***Mealstream Series 5 CTM3 240v 60Hz
FCC Approval***

Additional Information

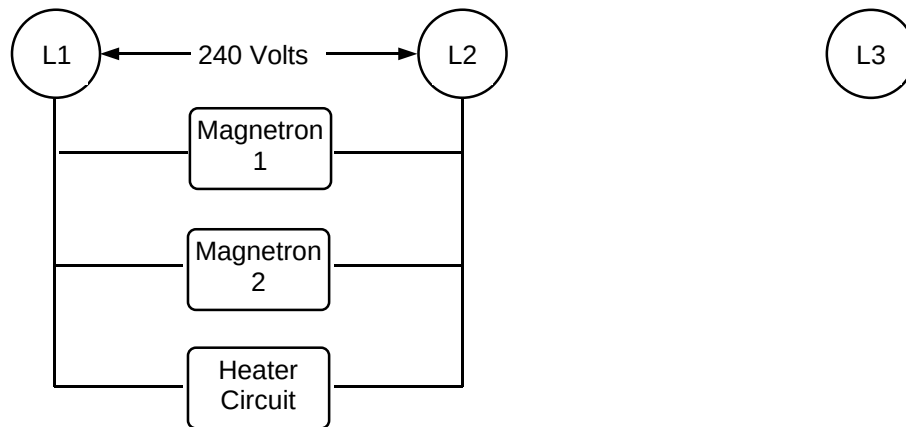
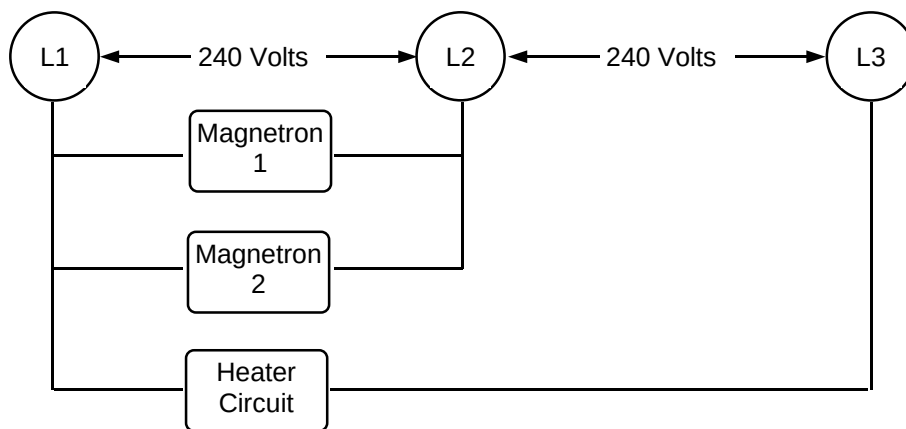
A small modification can be made to the 240v 60 Hz unit to enable the units to run on a three phase supply.

In single phase both the magnetrons and the heater circuit are run on the same phase.

In three phase the heater is run on the third phase alone. This is done by removing a link to the terminal block.

Please note that this modification will take place when the oven is in production.
